# STANDARD PLANS SUMMARY

INTERSTATE ROUTE H-1 REHABILITATION
SALT LAKE BOULEVARD TO AIRPORT VIADUCT
FEDERAL-AID PROJECT NO. NH-H1-1(275)

# TYPICAL SECTIONS & DETAILS

# PAVEMENT GRADE PLANS

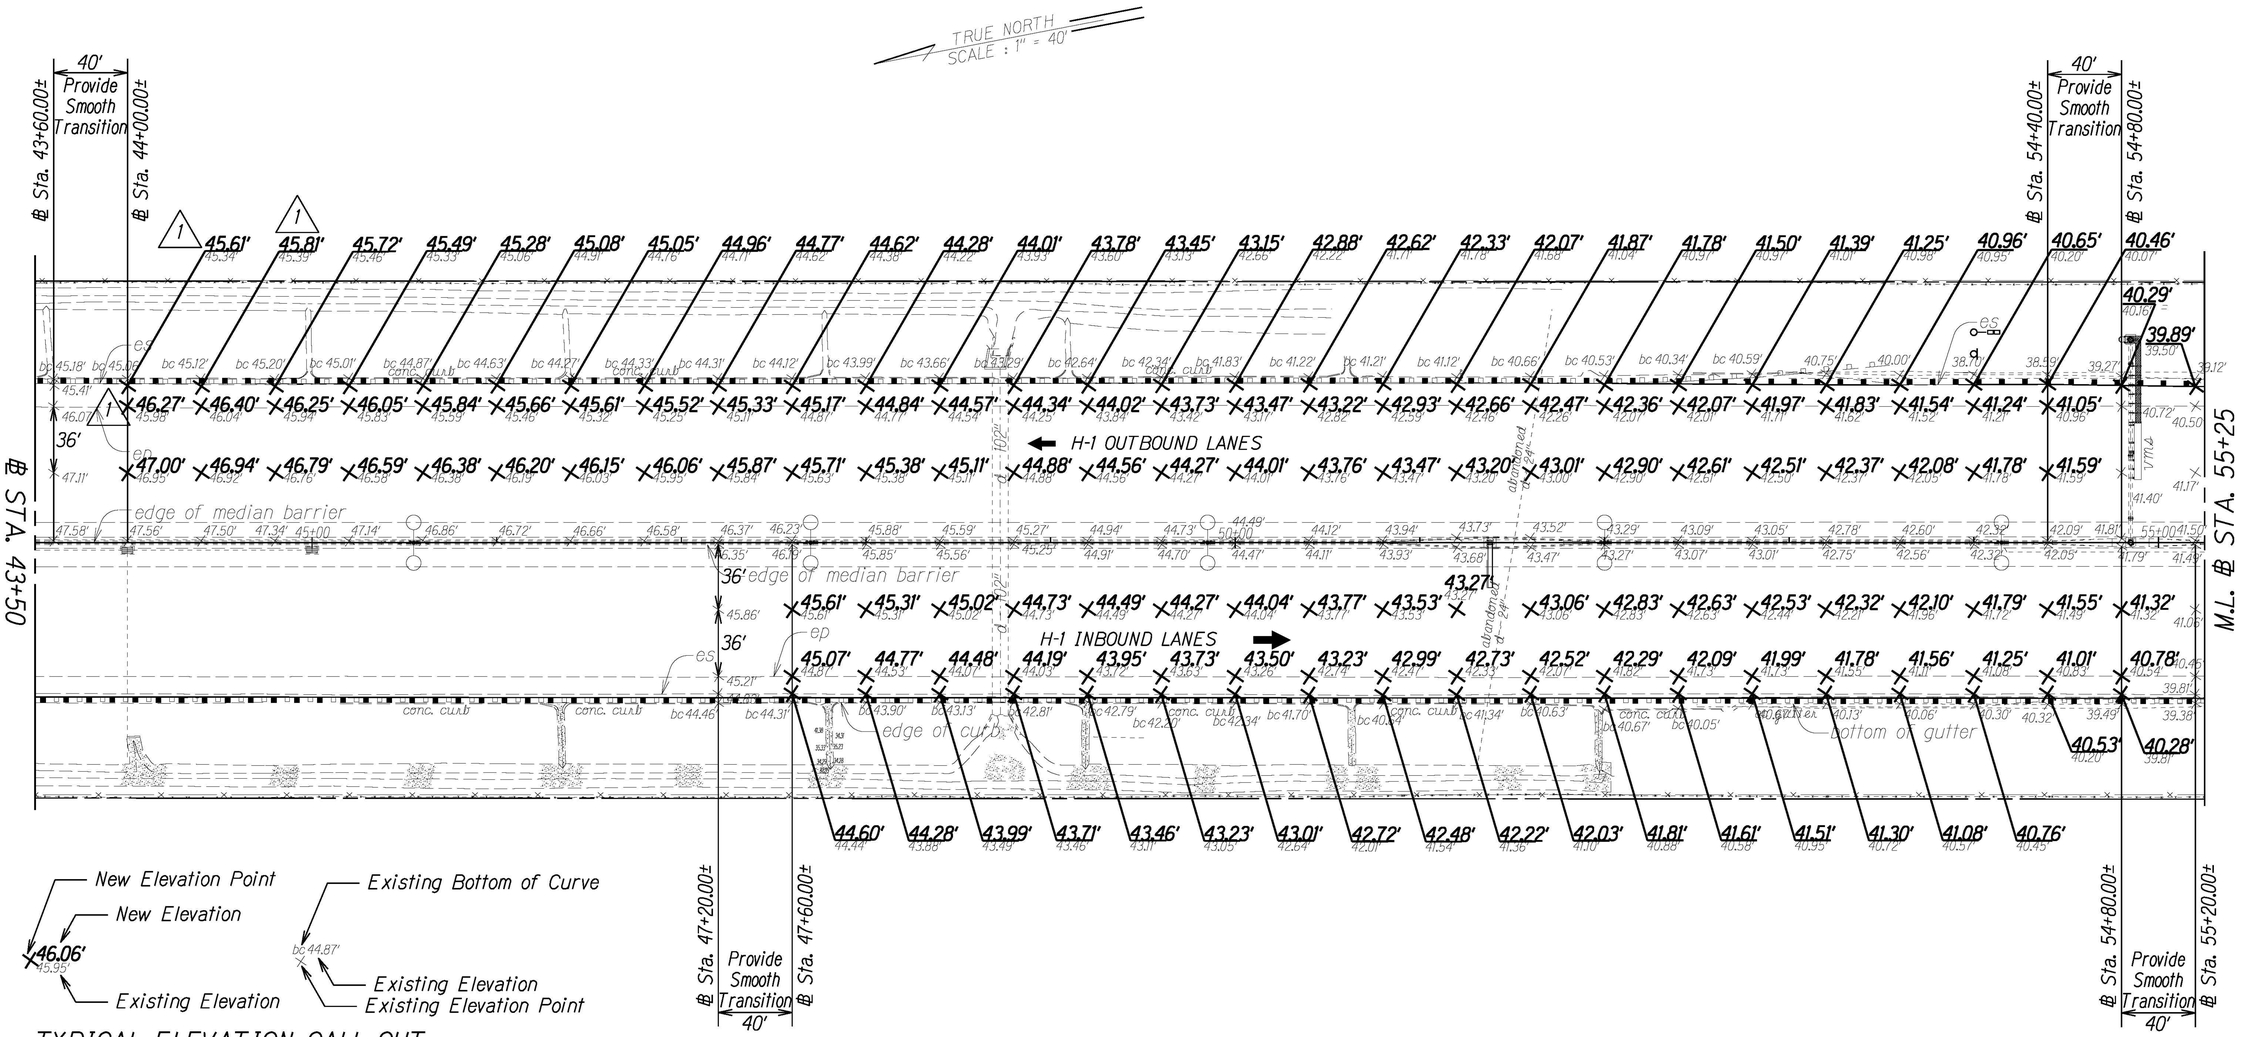
| 1 | 11/10/21 | Added Note 3. Revised Various New Grade Elevation Points. Added smooth transition callout at ℄ Sta. 54+40 (Outbound). |

1. See General Note #30.
2. Contractor to provide all necessary equipment and services (including surveyor) needed to construct pavement to shown finish grades. All costs shall be incidental to the contract work.
3. Spot elevations shown are spaced at 40' o.c.

# PAVEMENT GRADE PLANS

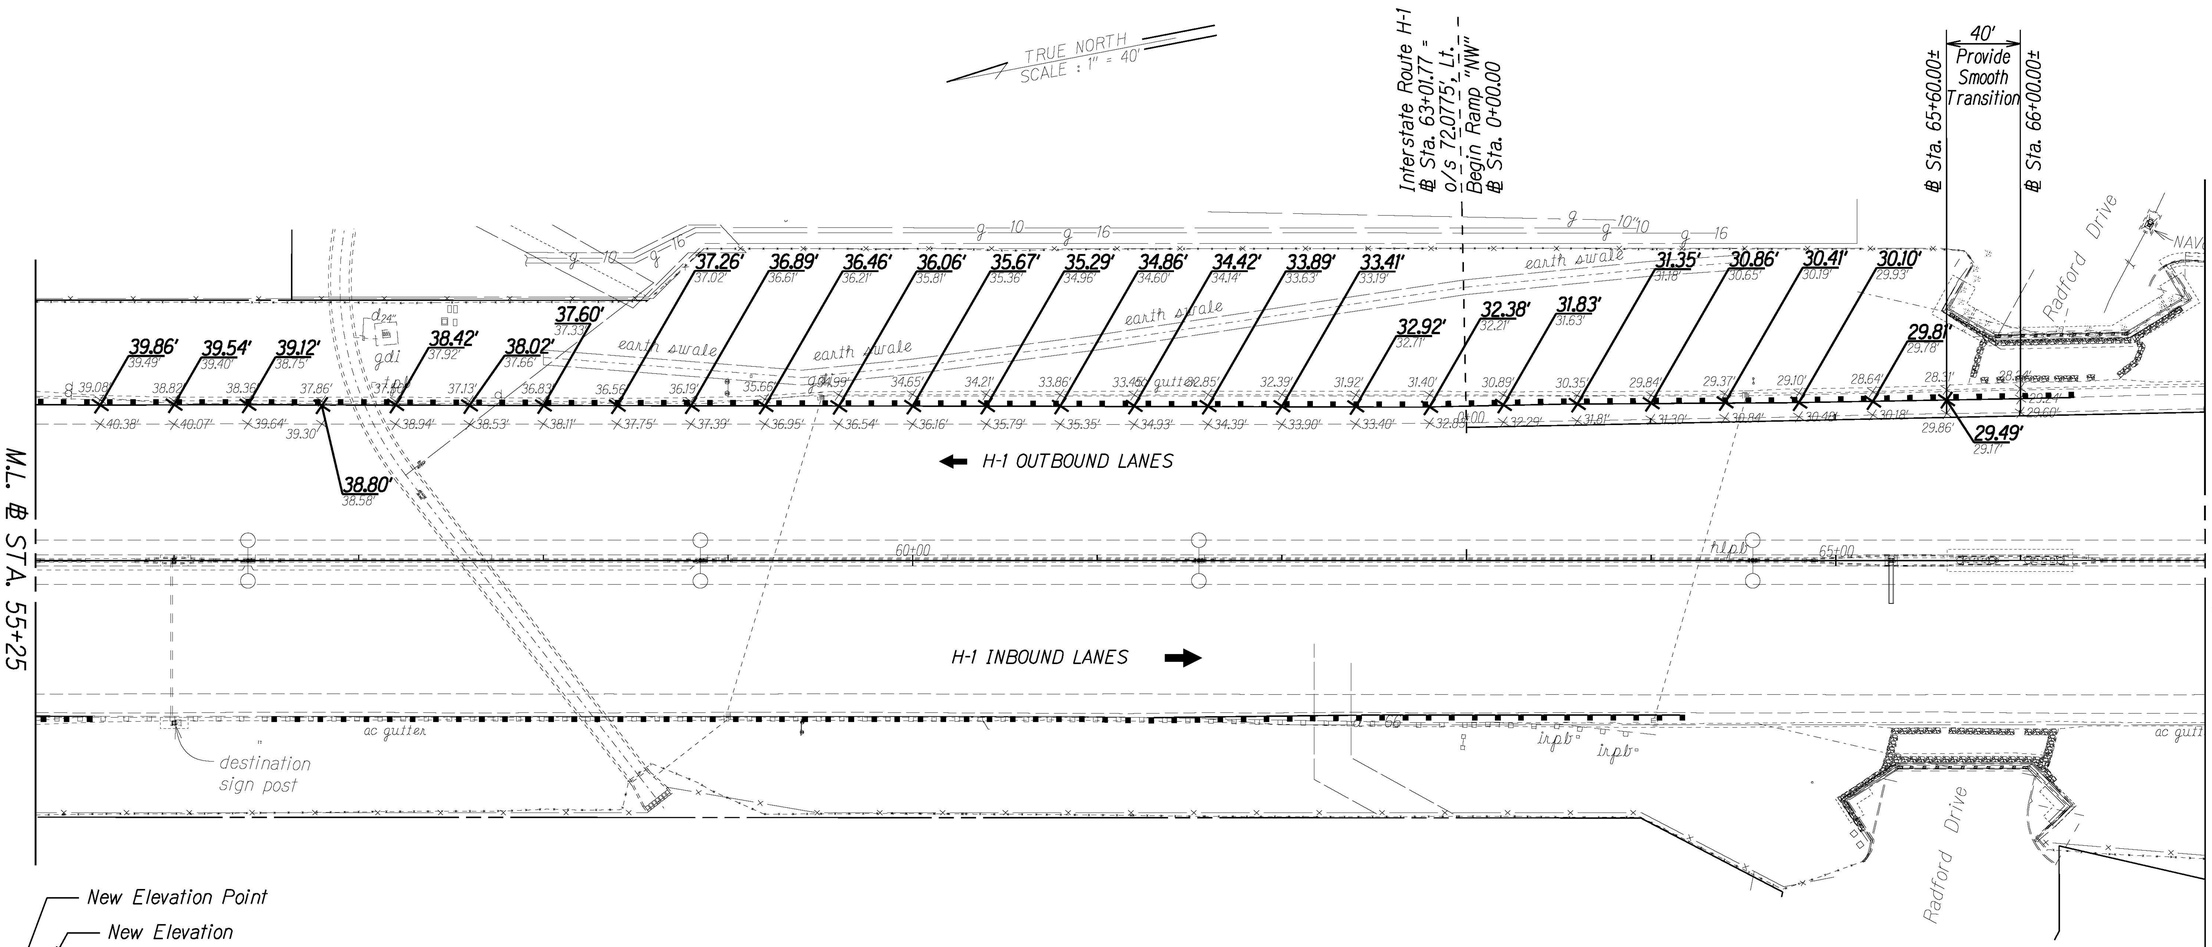
| DATE | REVISION |
|---|---|
| 1 11/10/21 | Added Note 3. |

1. See General Note #30.
2. Contractor to provide all necessary equipment and services (including surveyor) needed to construct pavement to shown finish grades. All costs shall be incidental to the contract work.
3. Spot elevations shown are spaced at 40' o.c.

1 RVSD POLE INSTALLATION WITH TRANSFORMER BASE

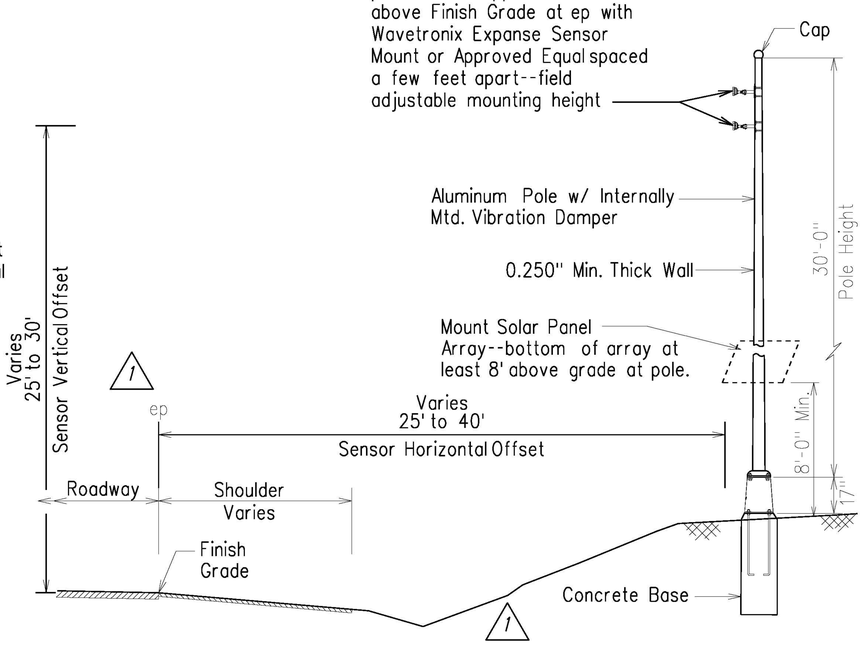
| DATE | REVISION |
|---|---|
| 11/10/21 | Clarified and revised notes and details. RVSD Pole Installation With Transformer Base detail revised to show offsets. |

1 Two Radar Sensors (Wavetronix Expanse XP20 Sensor or Approved Equal) banded to pole--mount approx. 25' to 30' above Finish Grade at ep with Wavetronix Expanse Sensor Mount or Approved Equal spaced a few feet apart--field adjustable mounting height
